DATE: May 14, 1982  
REVISION DATE: August 26, 1983  
BULLETIN NO.: I/O:41  
PRODUCT: 26-4104 Model II Hires Graphics Board  
SUBASSEMBLY: N/A

PURPOSE: To correct small hash marks in the first eight inches of the left side of the video display.

BULLETIN NO: I/O:1000

PRODUCT: 26-1245 Tandy Disk Cartridge System  
26-1246 Drive 1 Upgrade Kit

Figure 1

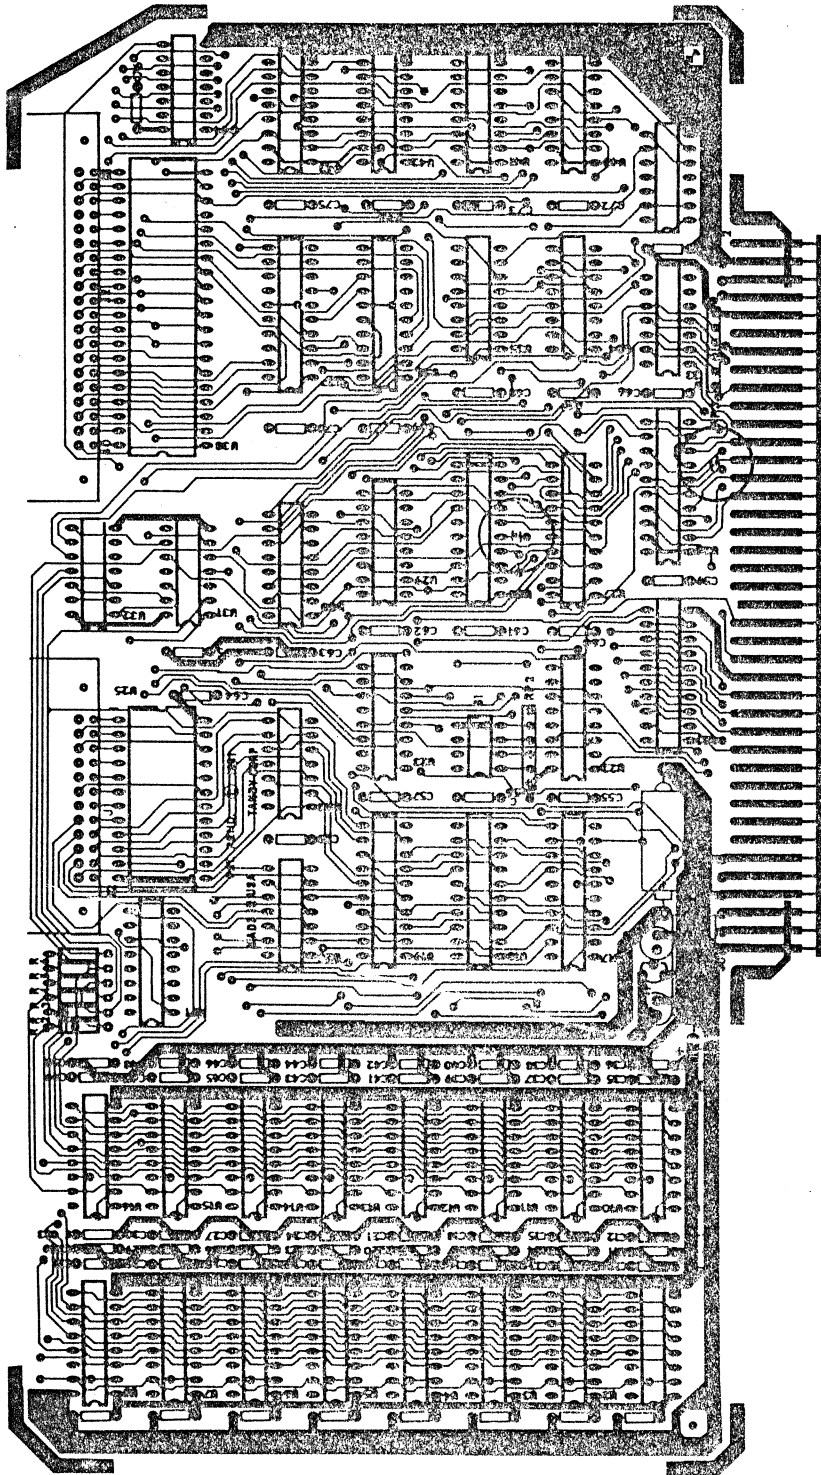
DISCUSSION/PROCEDURE: This problem will occur when updating the video memory on revision A boards. To modify install the following cuts and jumpers:

Cuts: U26 pin 6 (pin 26 on the edge card connector)  
(See figure 1) U28 pin 5 (cut at the first feed through)

Jumpers	U38 pin 39	to	U32 pin 4
	U38 pin 40	to	U32 pin 5
	U32 pin 6	to	U26 pin 6
	U26 pin 14	to	U28 pin 5
